ARCHITECTURAL DESIGN NARRATIVE BACKGROUND

8500 N PFEIL STREET, MILWAUKEE, WI 53224

CPC STAFF REVIEW COMMENTS:

Z:\PROJECTS\2018\1254.00-WI\CAD\SHEETS\1254.00-WI LANDSCAPE PLAN.DWG

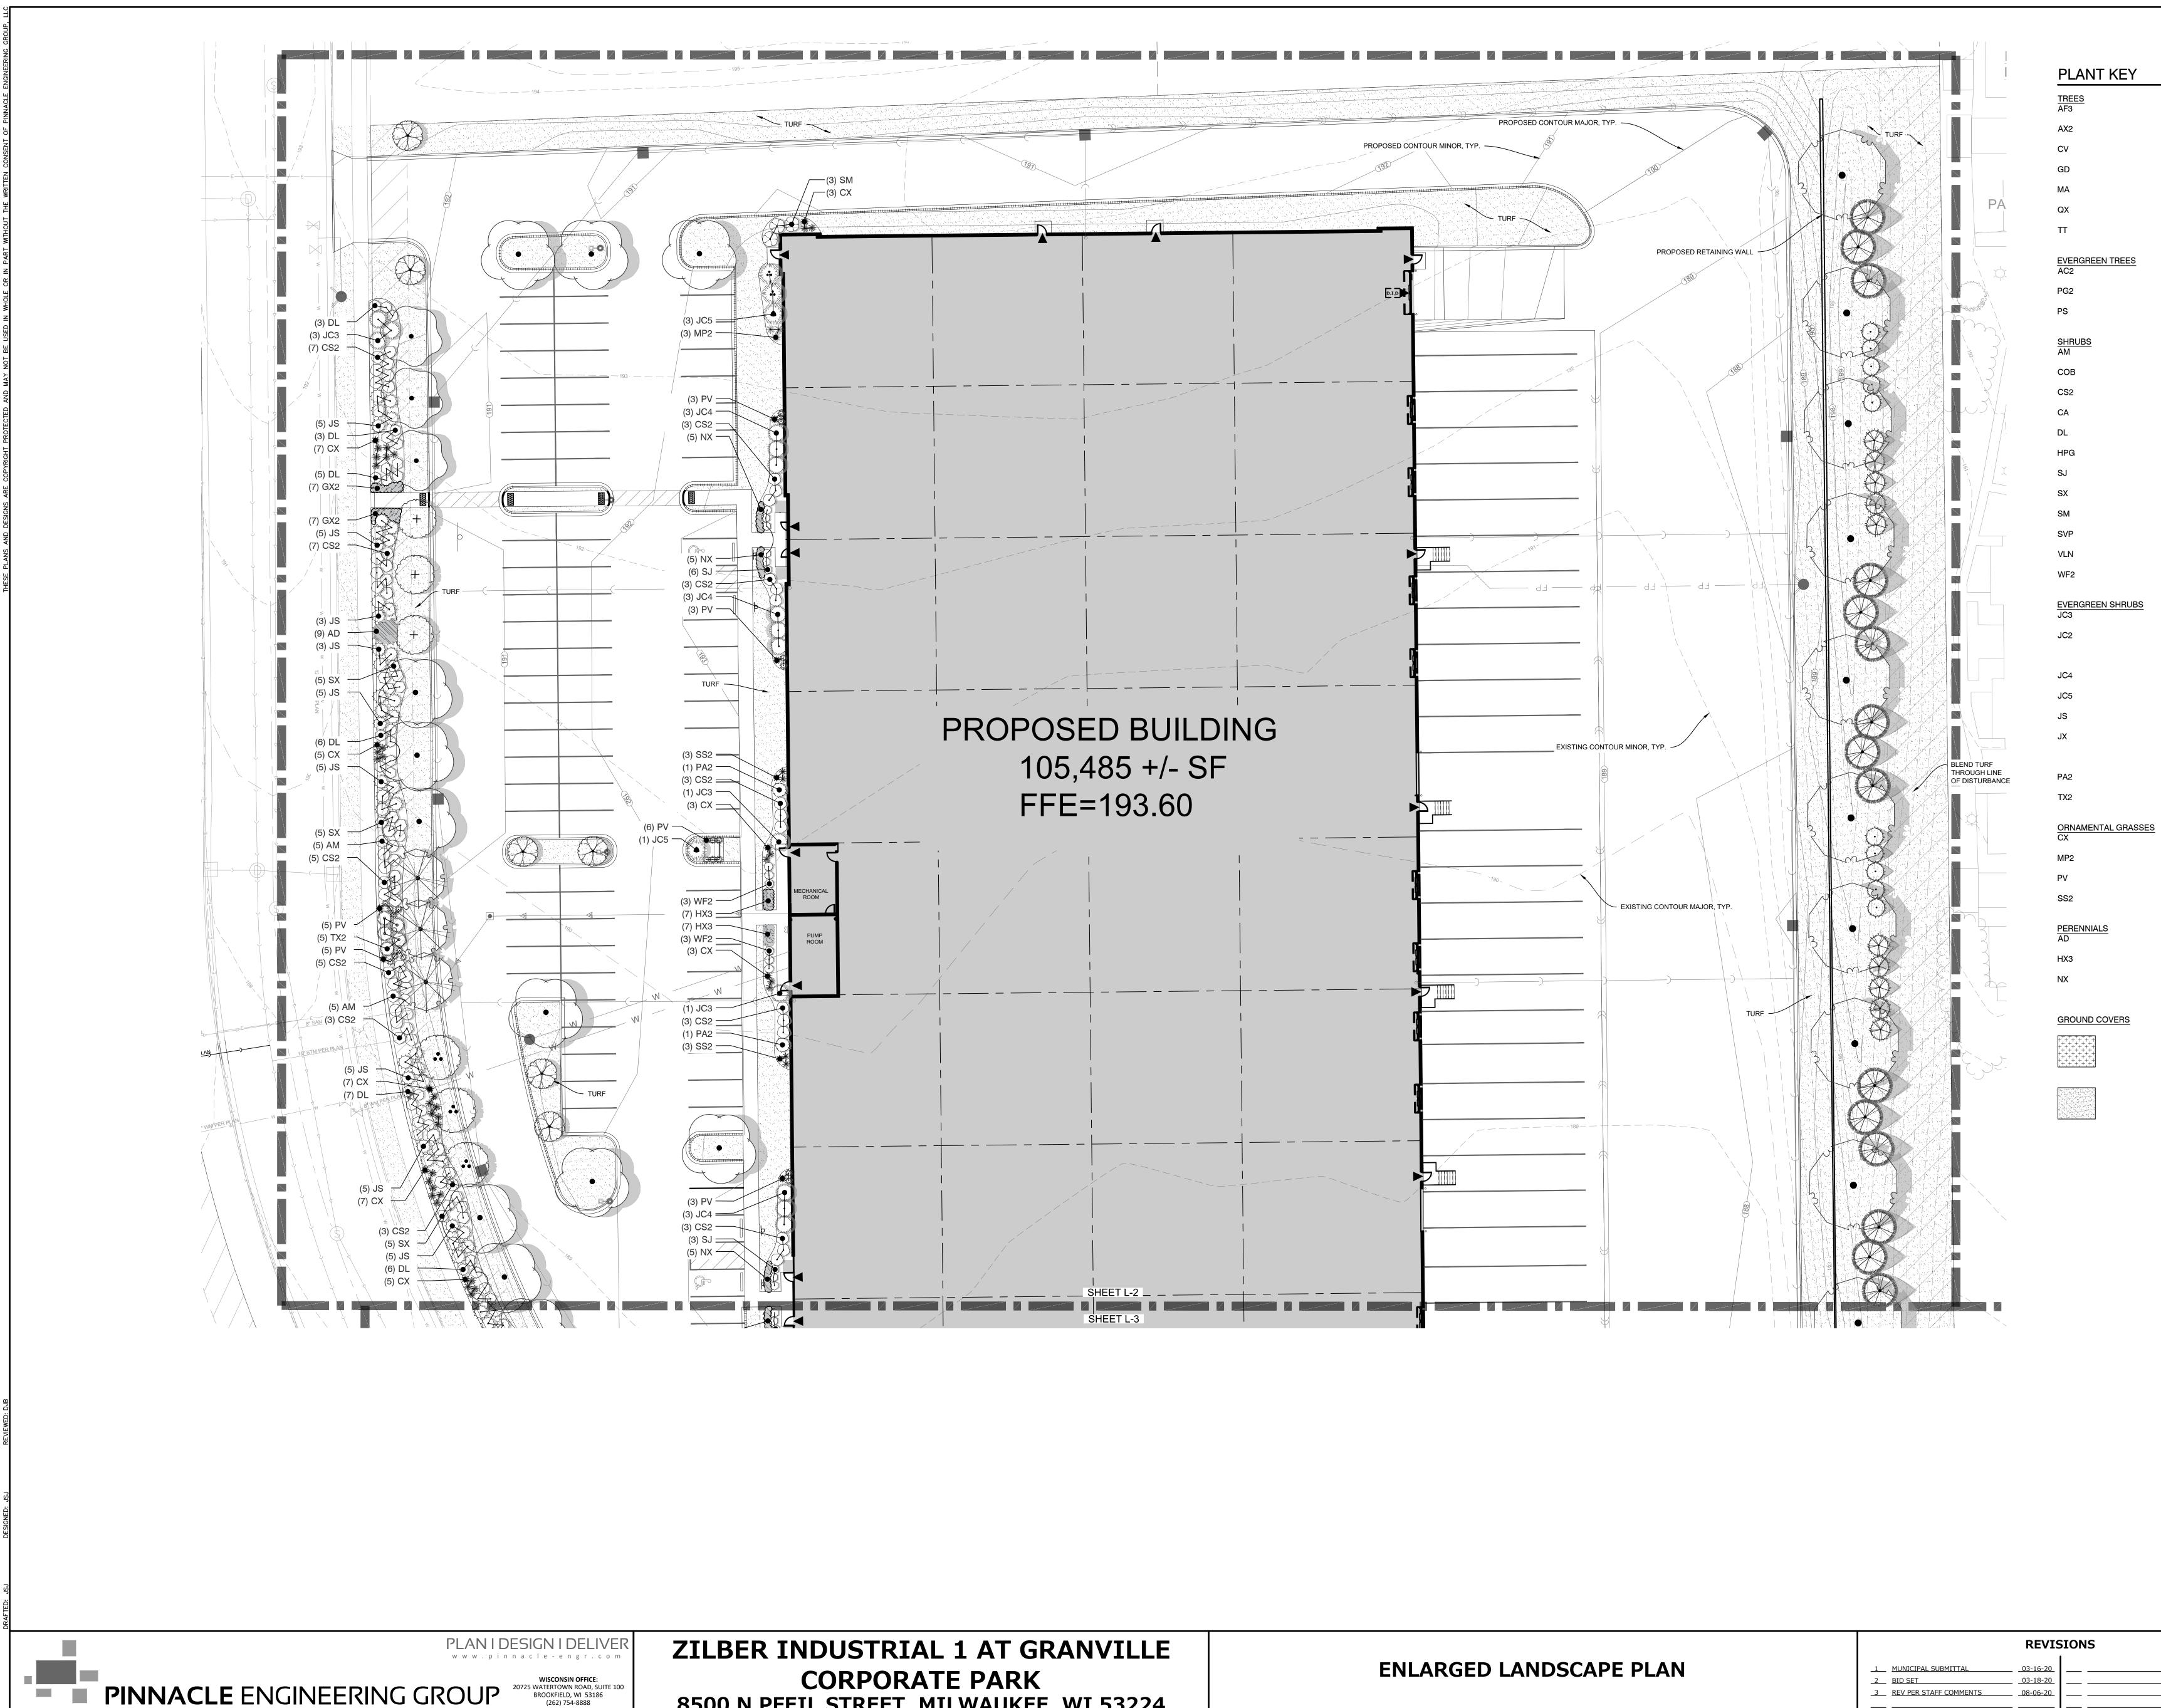
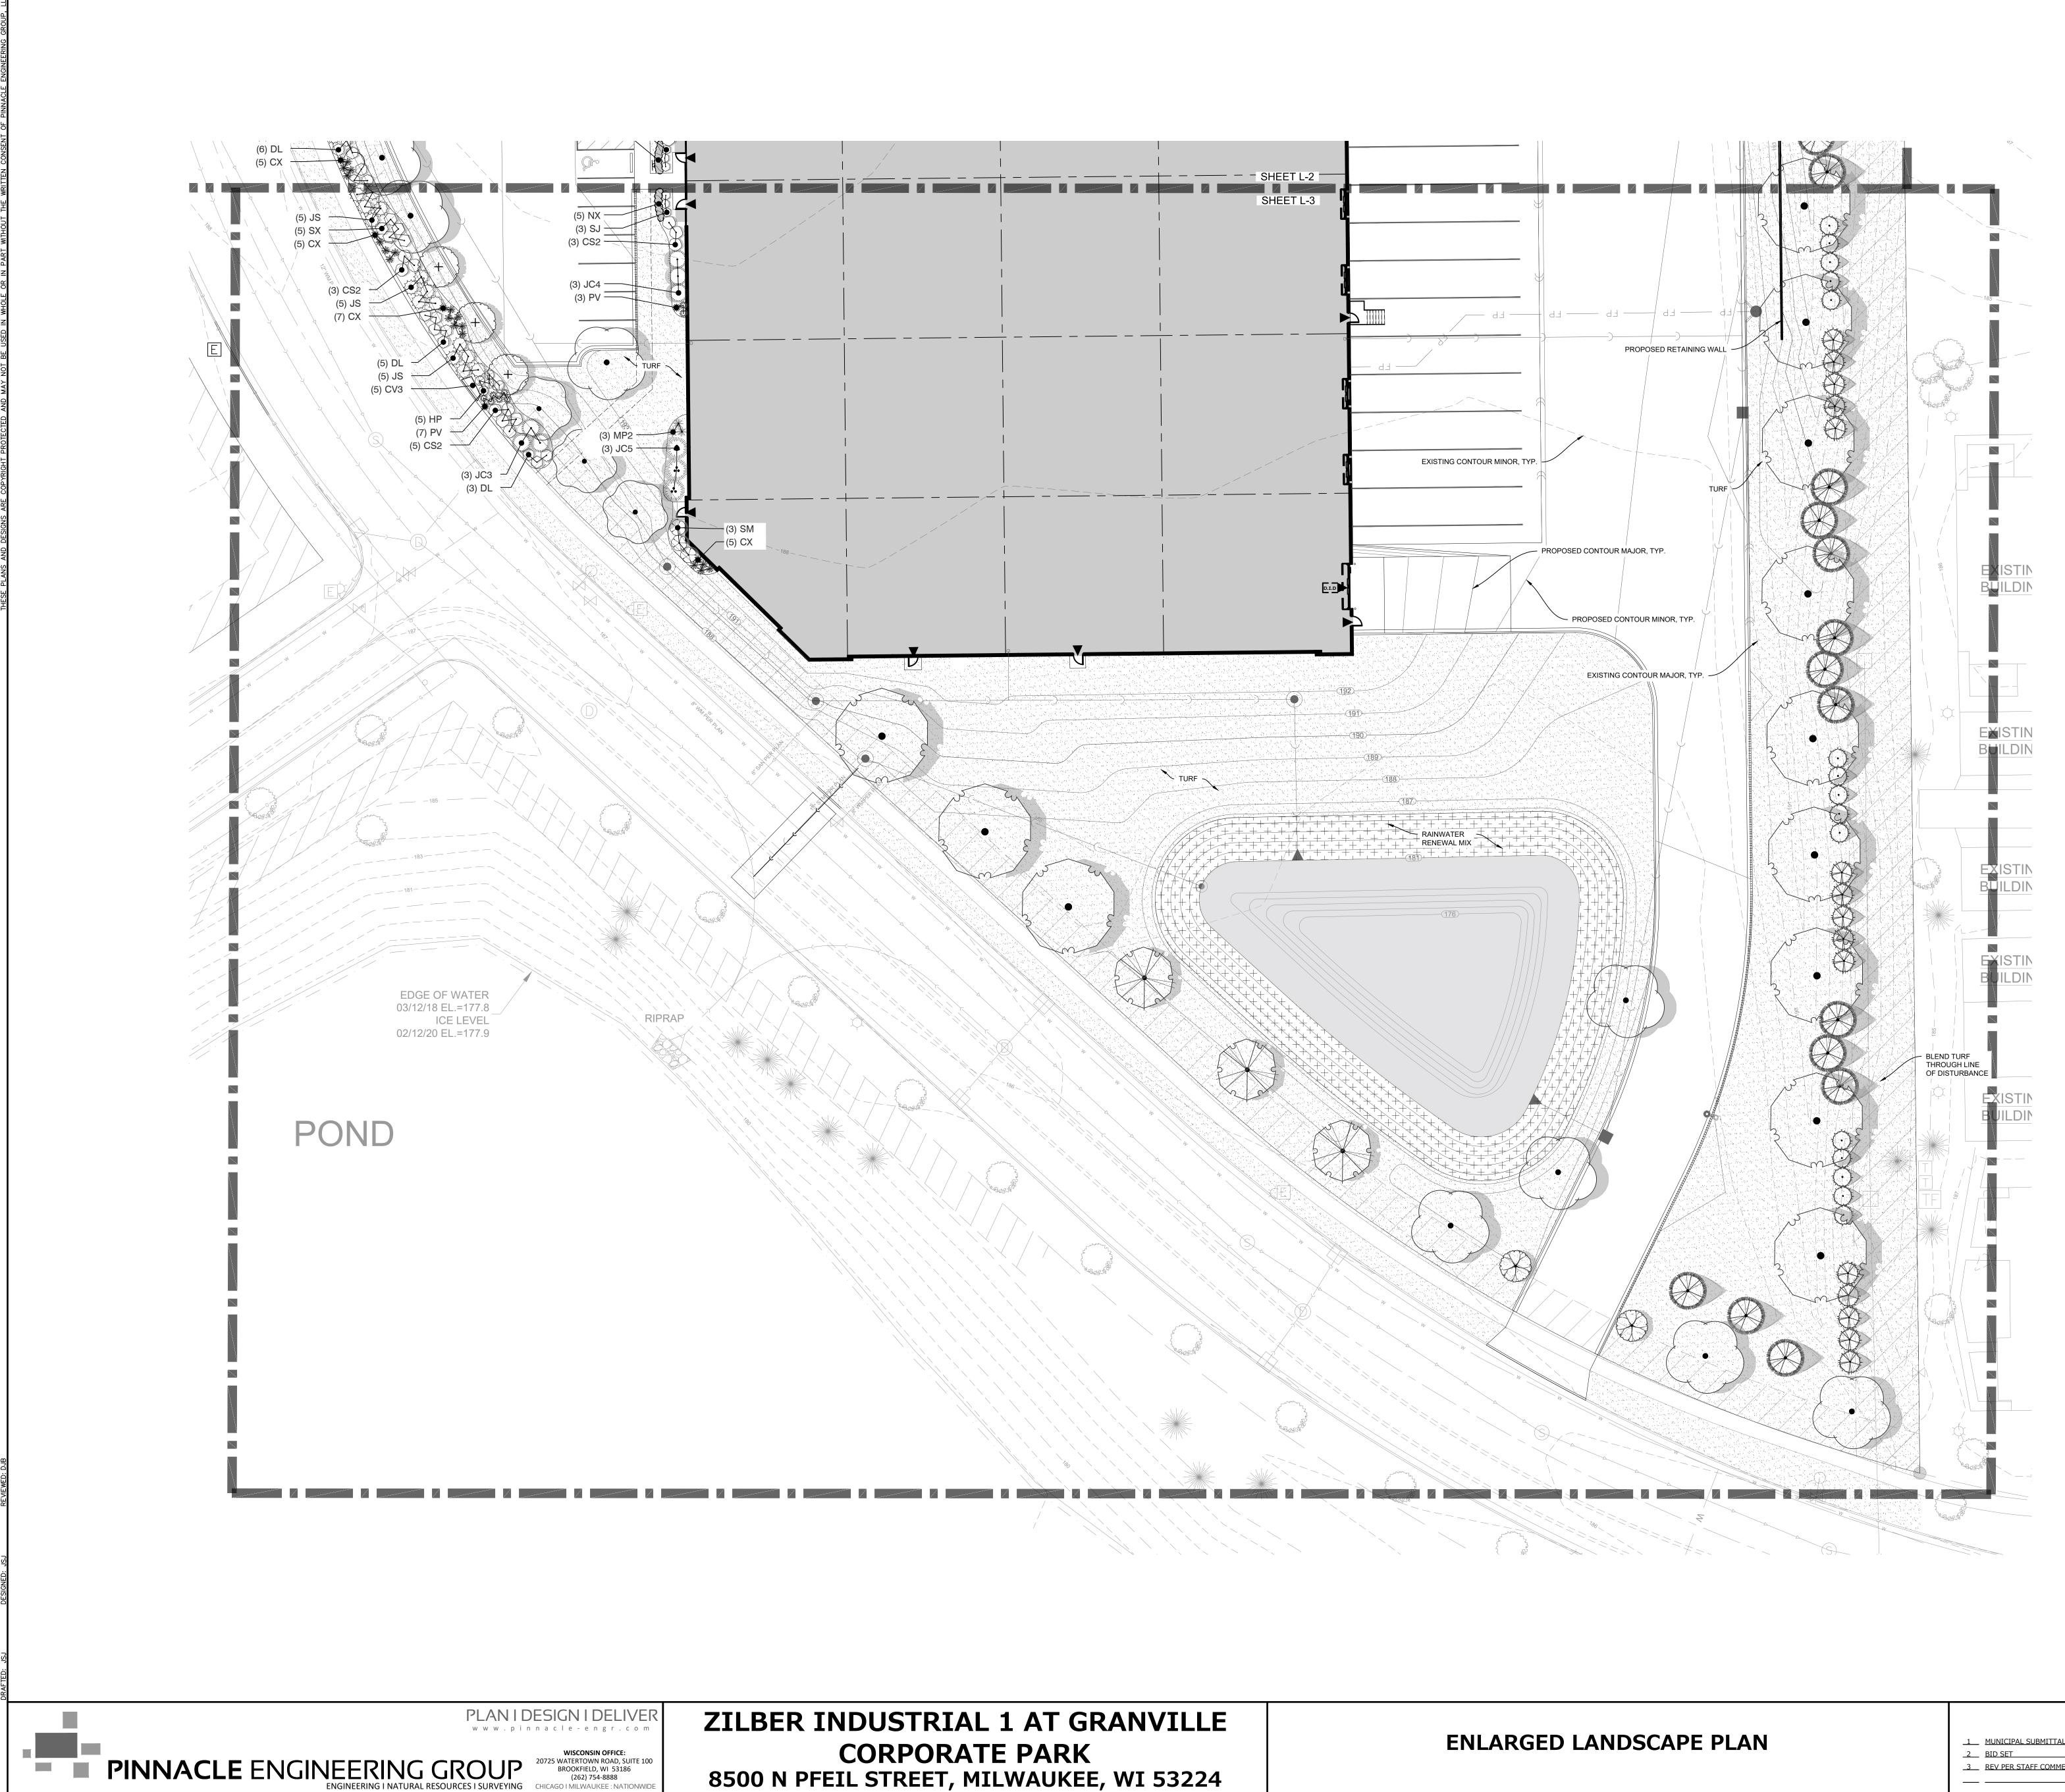
- b. The landscape along the street edge of the parking lot appears substantial; however, the design shown on the plan places the required trees in the right-of-way between the curb and sidewalk rather than on private property. While this may be acceptable (with the Dept. of Public Works' approval), we ask that you clarify why the trees cannot be placed on the property itself. The Landscaping was revised to be on private property per staff recommendations.

- c. The rear setback for the landscape buffer seems to be in line with the DIZ standards. However, the landscape screening within this buffer should follow the industrial district residential transition standards in the <u>zoning code</u> (see Table 295-805-4-d in sub chapter 8 of the zoning code). This substantial buffer is important as a means to screen any noise or sight lines from the existing residential condo development immediately east of the site.

The design team understands the current layout satisfies the DIZ requirement, but maybe not be in line with the Zoning code. We would submit that a BOZA review will be need to resolve to be in accordance with Table 295-805-4-d in sub chapter 8 of the zoning code. There is an exception that may allow current layout to remain, along with community outreach feed back of the adjacent residence, Zilber is committed to providing a design per code while also being acceptable to the community. The Design team would proposed that we be allowed to follow the 'alternative residential buffer standards'. We can revise our planting plan to include shrubs every 5' in lieu of the evergreen requirement.
